Howse Property Project
Proponent Responses to: EIS Technical Review: Part 2
September 21, 2016

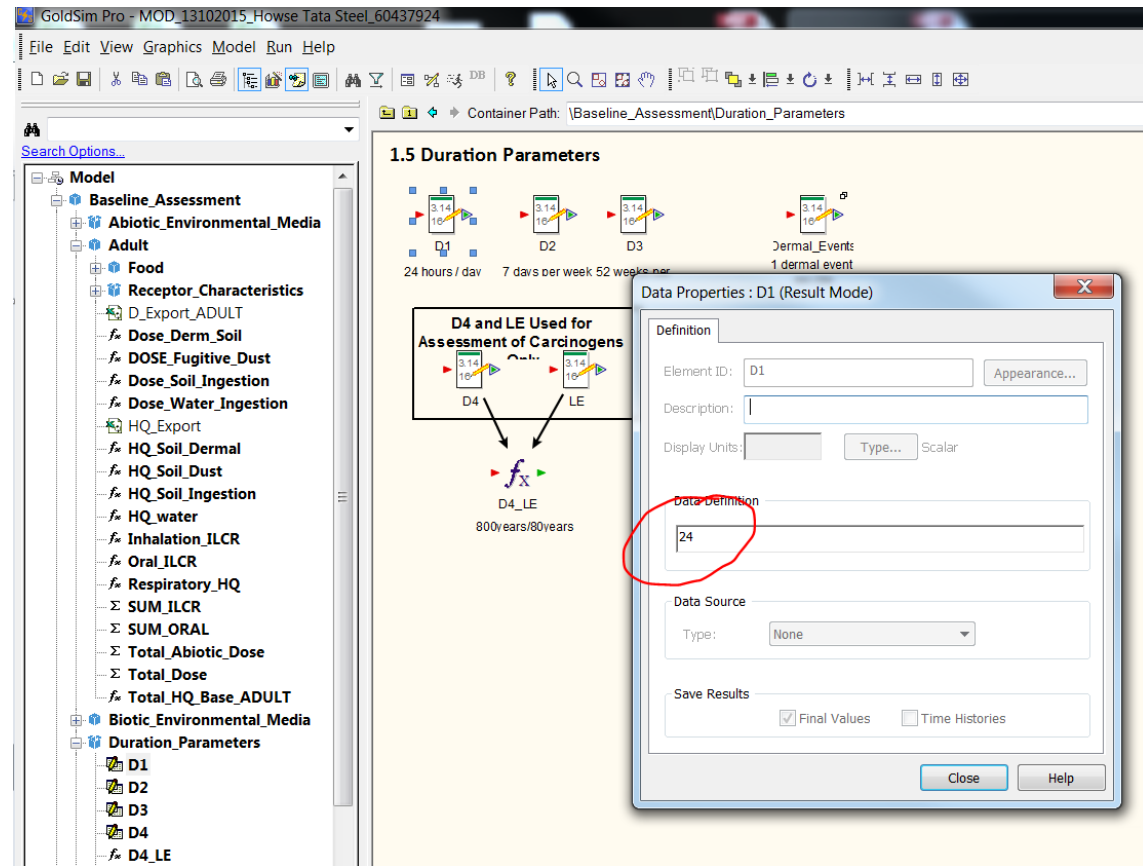
CEEA 38	HC-IR-32	5(1)(b) Transboundary 5(1)(c)(i) Aboriginal Peoples’ Health/socio-economic conditions	6.3.4	Appendix VI – Table 7.1 #CE15	CE15 states that for dust control, “the dust-control liquid used must comply with GNL regulations.” No additional information about the specific products that are being considered or the MSDS sheets associated with these products, including human toxicological information, was presented.	<ul style="list-style-type: none"> Provide chemical information, including specific product names, active ingredients and toxicity information (such as can be found on an MSDS sheet) about the products that are being considered for dust control. Confirm that the type of product to be used will respect relevant regulations. If chemicals were not included in the effects assessment, provide analysis to indicate potential human and environmental effects related to the use of the chemicals.

<p>HML Answer</p> <p>The Proponent is currently investigating several dust-control products: water, calcium, pulp and paper residues, and biological components. All of these are being considered for the cost-effectiveness and environmental effects.</p> <p>A preliminary analysis is provided here:</p>

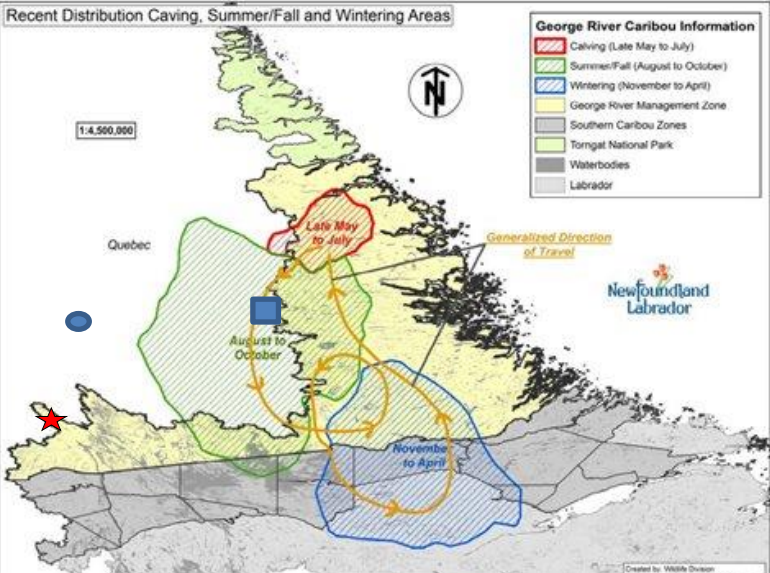
CEAA 77	NL – Wildlife Division, CEAA	5(1)(c)(iii) Current Use of Lands and Resources for traditional purposes	6.3.4	9.2.2 Follow-up	<p>The EIS suggests that caribou surveys will include fixed-point observations and ATV-based searches. It states that <i>“if ground-based surveys do not prove to be useful or feasible, HML will initiate aerial surveys.”</i></p> <p>Ground based caribou surveys are generally not useful to inform mitigation measures or monitoring programs. Rather, aerial surveys conducted in winter provide more useful information.</p>	<ul style="list-style-type: none"> Provide information on the caribou monitoring program, including whether aerial surveys would be conducted in winter months and how frequently these surveys would occur.

Answer sent to CEAA August 22						
HML Answer
